APPLICATION NO.	FILING DATE	FIRST NAMED INVENTOR	ATTORNEY DOCKET NO.	CONFIRMATION NO.
10/779,751	02/18/2004	Jin-Ho Park	1349.1292	2039
21171 STAAS & HAL	7590 11/07/200 SEY LLP	EXAMINER		
SUITE 700		UHLENHAKE, JASON S		
WASHINGTON	RK AVENUE, N.W. N, DC 20005		ART UNIT	PAPER NUMBER
			2853	
			MAIL DATE	DELIVERY MODE
			11/07/2008	PAPER

Application No.	Applicant(s)				
	10/779,751	PARK ET AL.				
Office Action Summary	Examiner	Art Unit				
	JASON S. UHLENHAKE	2853				
The MAILING DATE of this communication app Period for Reply	ears on the cover sheet with the c	orrespondence address				
	VIC OFT TO EVEIDE AMONTHY	C) OD THIRTY (20) DAVC				
A SHORTENED STATUTORY PERIOD FOR REPLY WHICHEVER IS LONGER, FROM THE MAILING DA  - Extensions of time may be available under the provisions of 37 CFR 1.13 after SIX (6) MONTHS from the mailing date of this communication.  - If NO period for reply is specified above, the maximum statutory period w  - Failure to reply within the set or extended period for reply will, by statute, Any reply received by the Office later than three months after the mailing earned patent term adjustment. See 37 CFR 1.704(b).	ATE OF THIS COMMUNICATION 36(a). In no event,

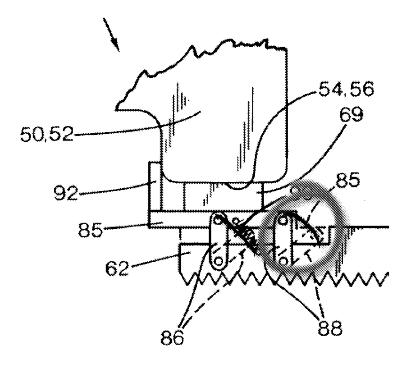
- **regarding claims 1, 11,** head caps (69) to revolve between a capping position and an uncapping position (Column 9, Line 50 Column 10, Line 9); a slider (62) to slide with respect to the head caps, and having wipers (68) mounted on a front end portion thereof; a slider movement unit to slide the slider (Figure 2; Column 8, Lines 25-40)
- a revolution unit (85) disposed between the head caps and the slider to revolve the head caps in association with the sliding of the slider with respect to the head caps (Figure 2; Column 9, Line 50 Column 10, Line 9)
- **regarding claim 10,** the slider slides in a perpendicular direction with respect to a printing direction of the printer heads (Figures 1-2)

Applicant argues that Taylor does not disclose that the caps revolve between a capping position and an uncapping position of printer heads. However the Examiner disagrees, as can be seen by Figure 2 the head caps (69) revolve (moves about an axis; to move in a curved path around a center or axis; roll) between a capping and uncapping position.
